**KEY ABBREVIATIONS**

HVL	HIGH VOLTAGE LINE		
HW	HOT WATER		
IN	INCH		
INSUL	INSULATION		
INT	INTERIOR		
INV	INVERT		
JST	JOIST		
LAM	LAMINATE; LAMINATED		
LAV	LAVATORY		
LF	LINEAR FOOT; FEET		
MAS	MASONRY		
MAX	MAXIMUM

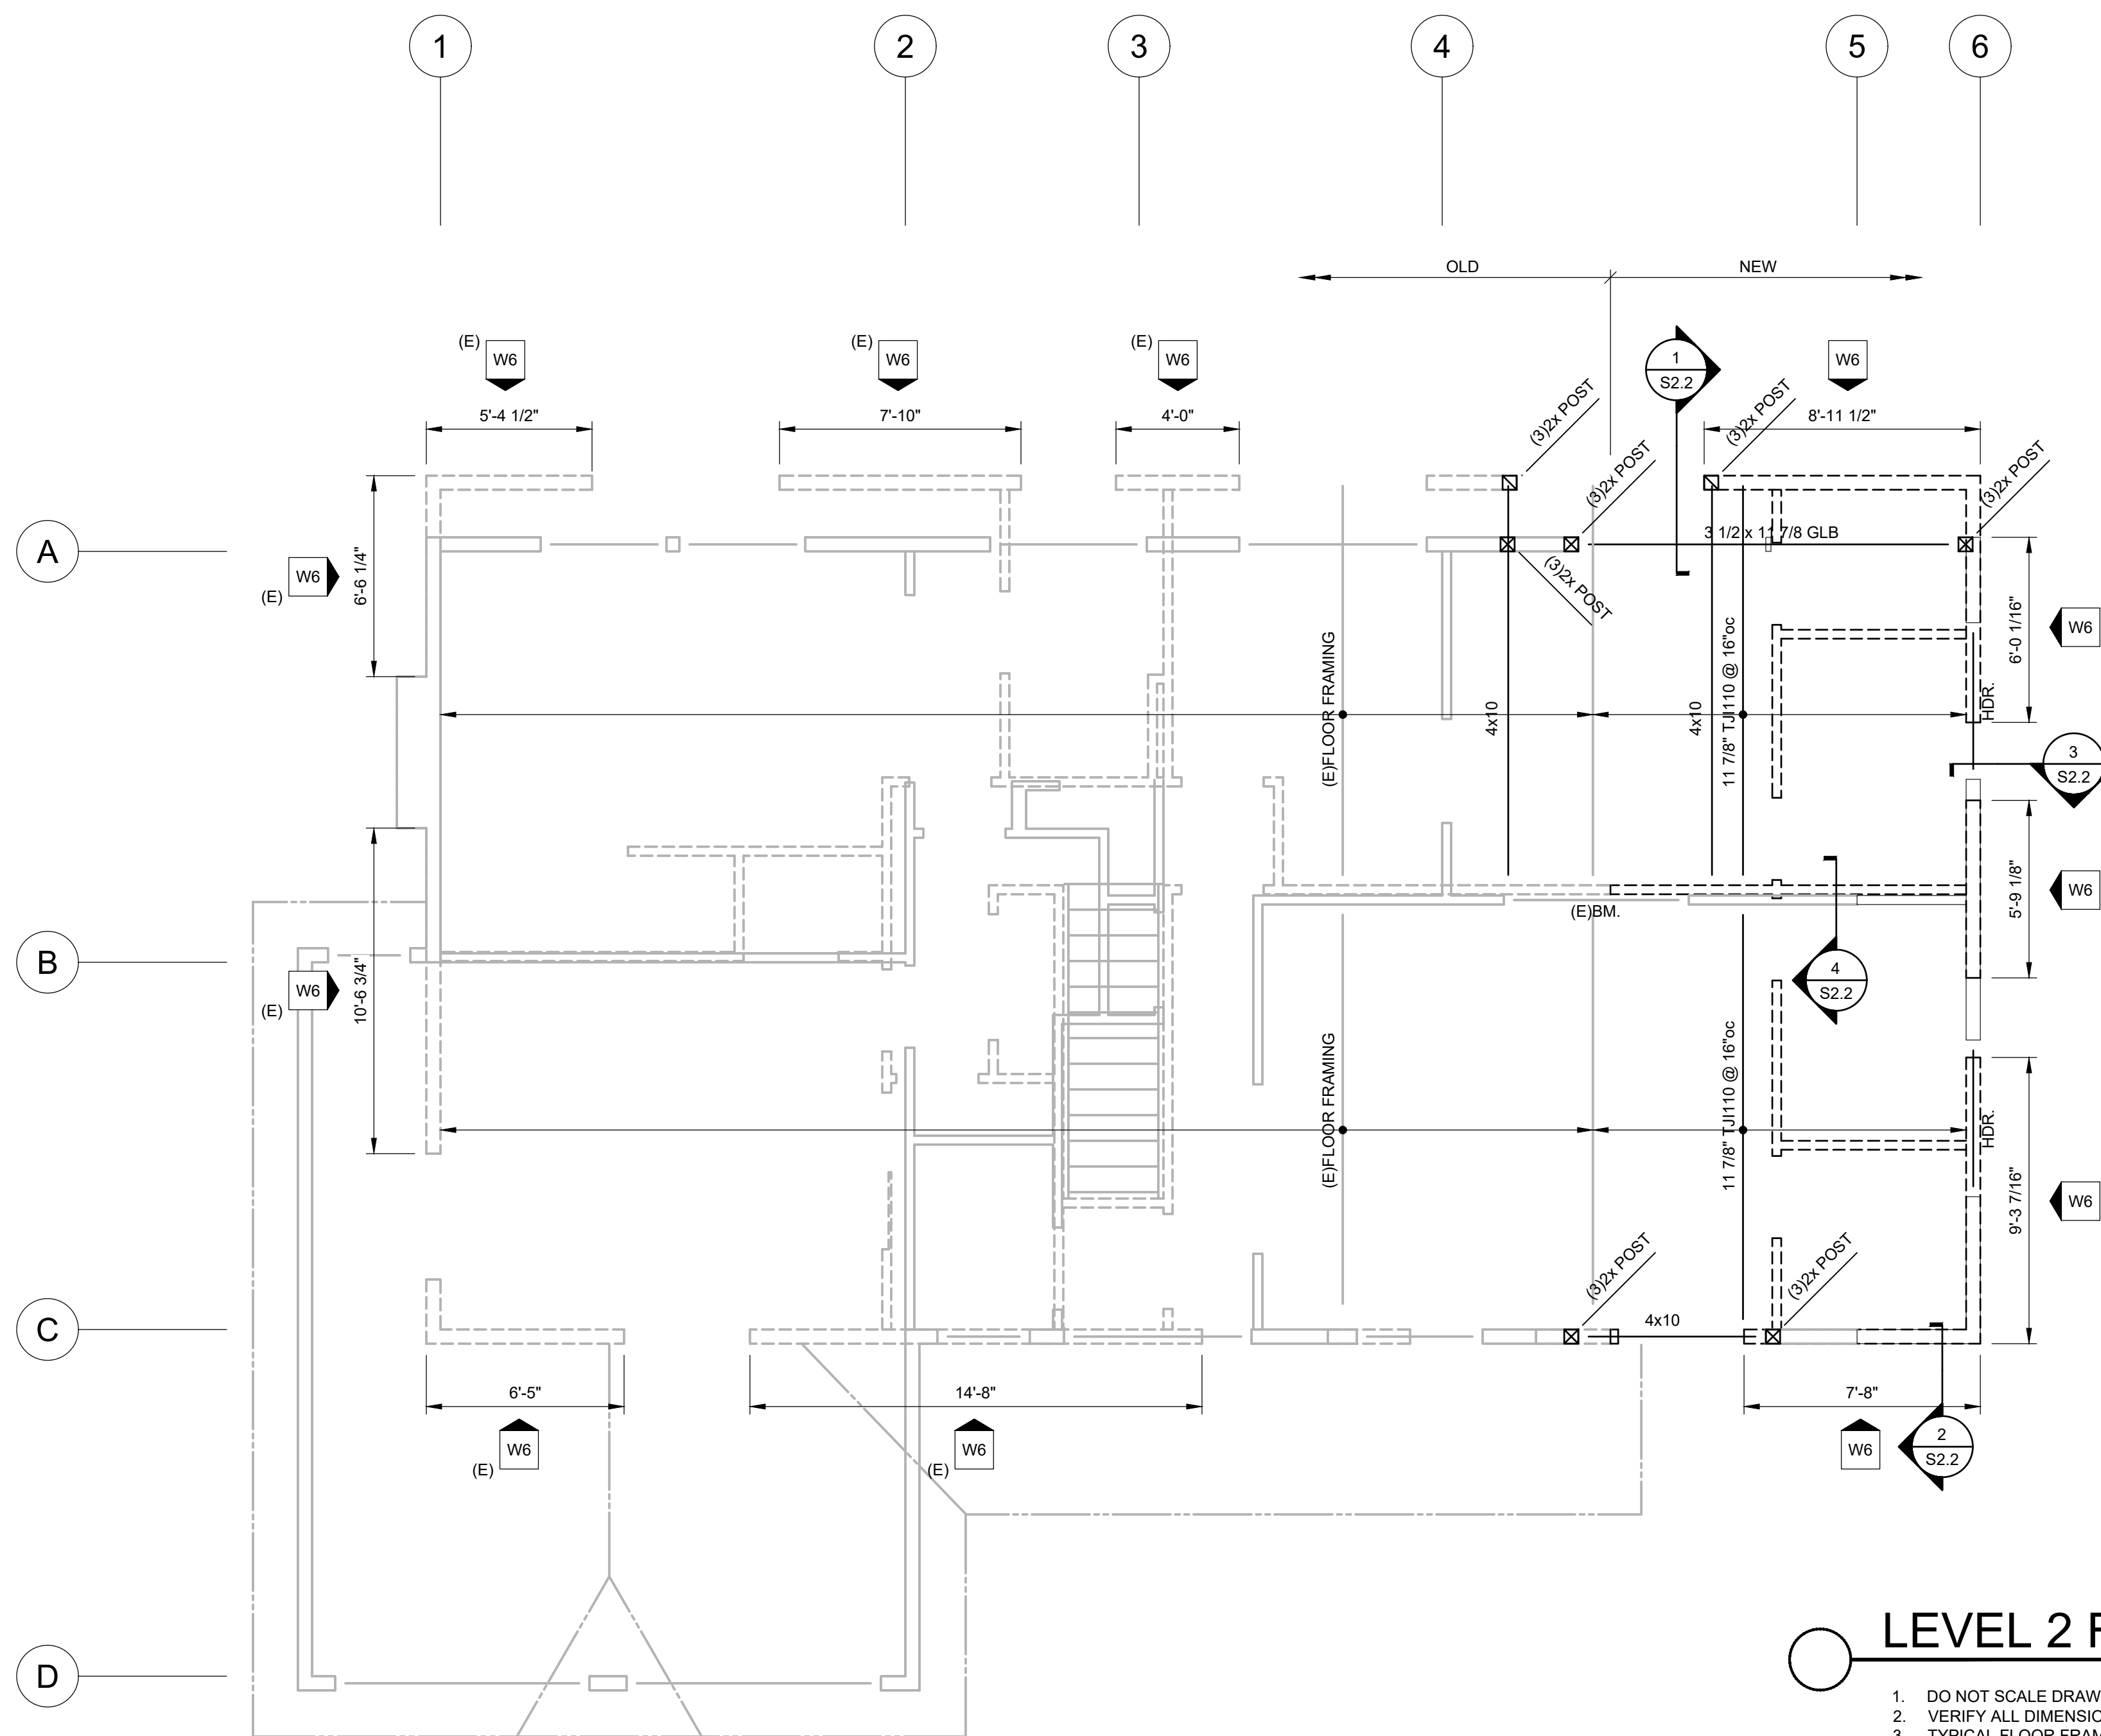
CONTRACTOR TO COORDINATE ALL TRADES AND VERIFY DIMENSIONS IN THE FIELD. OBTAIN OWNERS APPROVAL PRIOR TO ALL FIELD CHANGES. SEE ARCHITECTURAL DRAWINGS FOR ALL FLOOR AND WALL OPENING DIMENSIONS AND LOCATIONS, FLOOR AND WALL FINISHES, ETC.
